***STAFF COMMENTS FOR HISTORIC DISTRICT COMMISSION***

**Title:** **Historic Area Work Permit Application:  
HIST-7453-2016, retroactive reviews of fence,  
sheds, and tree removal**

**Address/Name:** 11 Russell Avenue / Brewster-Lipscomb House

**Figure 2.** Aerial of 11 Russell Avenue showing the discussed changes.

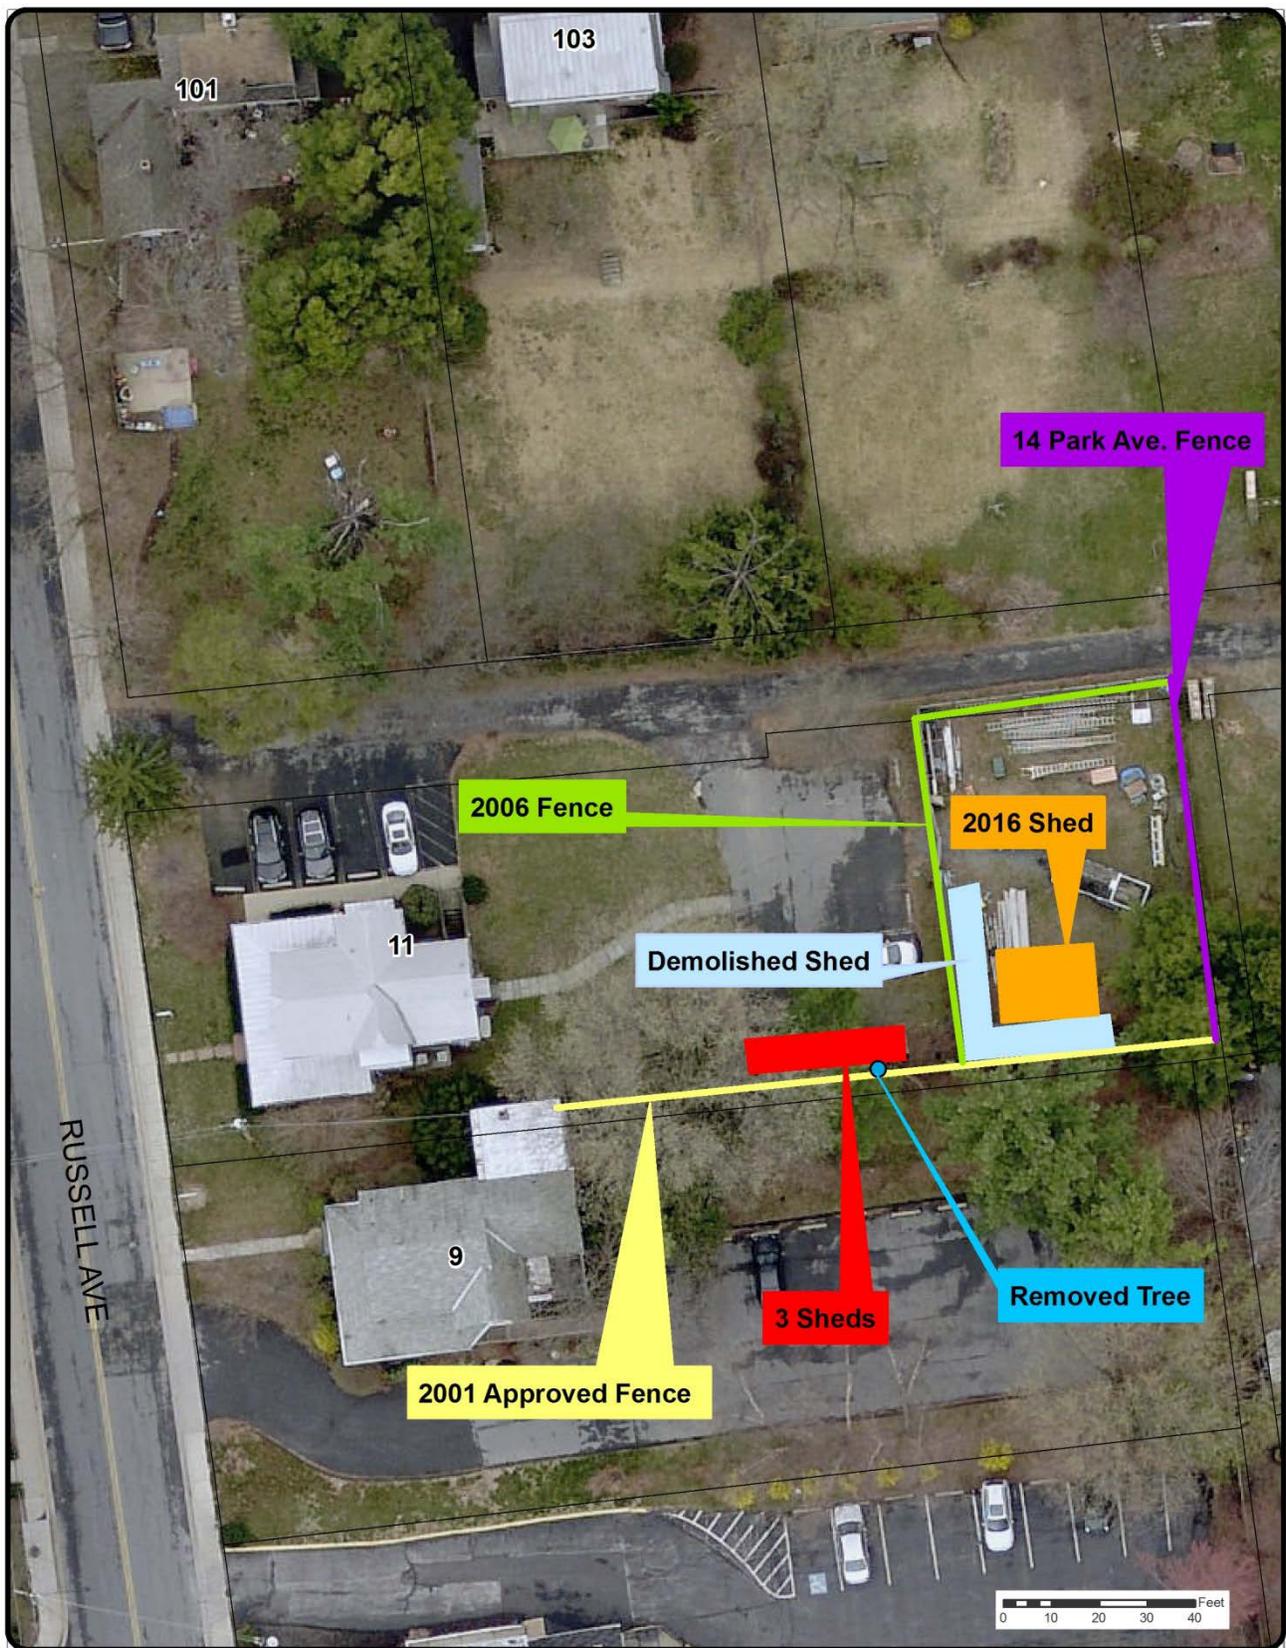
Staff does not condone the placement of a fence without receiving both HDC and City approval. The existing property owner successfully received a HAWP and a fence permit in 2001 for a section along the south boundary of the property, yet five years later he enclosed the rear of the property without first obtaining the necessary permits. Review is necessary to ensure the fence meets the design standards for the neighborhood and is constructed within the property boundaries. Staff does not dispute the necessity of a fence at the location in order to protect equipment related to the business located in the main building. It should be noted that the fence is about 175 feet from Russell Avenue at the closest point and not readily visible from that street. It also appears to meet the Guidelines' standards for fences. Therefore; Staff supports retention of the 2006 fence section if the applicant applies for a retroactive fence permit within thirty (30) days of the HDC's final action.

1. The applicant shall apply for one (1) retroactive fence permit; four (4) retroactive shed permits; one (1) retroactive tree removal permit; and one (1) Amendment to Final Site Plan Staff Approval within 60 days of the HDC's final action on HIST-7453-2016;
2. The applicant shall work with Staff to enclose the existing open pole shed with historically appropriate doors, prior to the issuance of a shed permit; and
3. The applicant shall plant a replacement tree within six (6) months of the HDC's final action of a species listed on the *Historic District Guidelines for the Brookes, Russell, and Walker Historic District and Individually Designated Sites* that measures at least two (2) inches in diameter at breast height (DBH).

**Exhibit 6.** The interior of the newly constructed pole shed located at the rear of the property at 11 Russell Ave., facing southeast (November 2016).

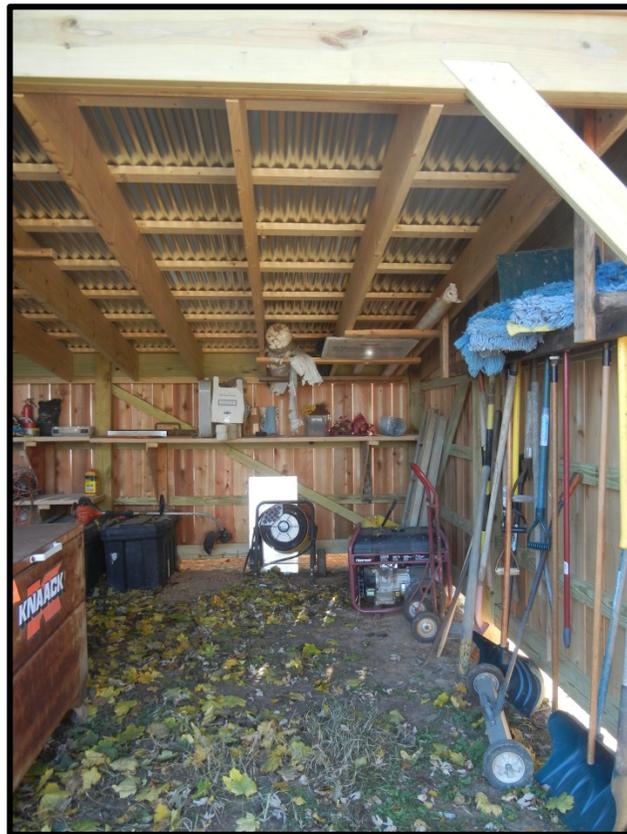
The existing structure is a 20-by-16 foot pole shed open on the north elevation. The pole shed is supported by treated 6-by-6 wood posts resting on concrete sunk 30 inches into the ground. The walls are covered on three sides by 6-inch wide cedar boards, and the shed roof is covered with corrugated metal. According to the applicant, the roof shape reflects the design of the rear of the Brewster/Lipscomb House.

Staff also does not condone the placement of four (4) sheds on the property. In all, the current property owner has placed five (5) sheds on the property and demolished one (1)—all without HDC and City review. Review is necessary prior to construction to guarantee the sheds meet design guidelines, City Code requirements, and meet building code safety standards. There is a historical basis for shed-roofed outbuildings in the Brookes, Russell, and Walker Historic District. At the March 26, 2014, the HDC approved HIST-4605-2014 (**Exhibit 7**), the demolition of two shed-roofed outbuildings at 19 Walker Avenue, a contributing building to the district. The main building was constructed in 1923, and the shed-roofed outbuildings likely had a similar construction date. The outbuildings at 19 Walker Avenue were completely enclosed. Therefore, Staff is of the opinion that the 320-square-foot open pole shed constructed at 11 Russell Avenue should also be enclosed in keeping with the traditional agricultural outbuilding designs of the neighborhood.

**Exhibit 6:** The stump of the removed pine tree (November 2016).

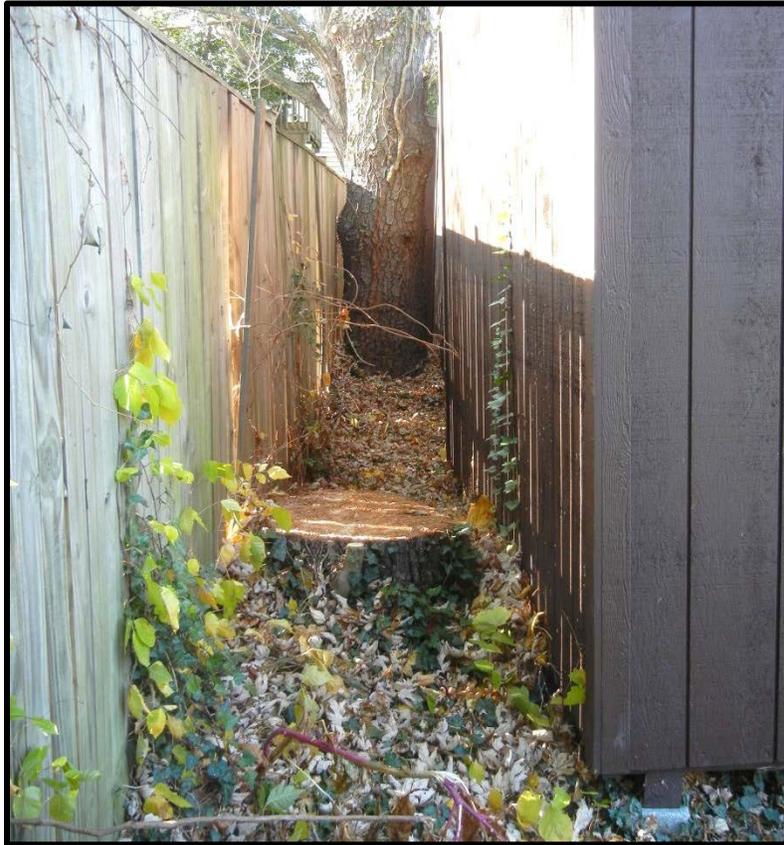
In October 2016, the applicant removed a white pine tree that measured approximately 26 inches in diameter. According to the applicant, the “tree was essentially dying and threatening our and our neighbor’s property and our parking lot” (**Exhibit 2**).

Finally, Staff supports the removal of the white pine tree so long as the applicant receives a retroactive tree removal permit within thirty (30) days of the HDC's final action and plants a replacement tree of a recommended species listed in the Guidelines.
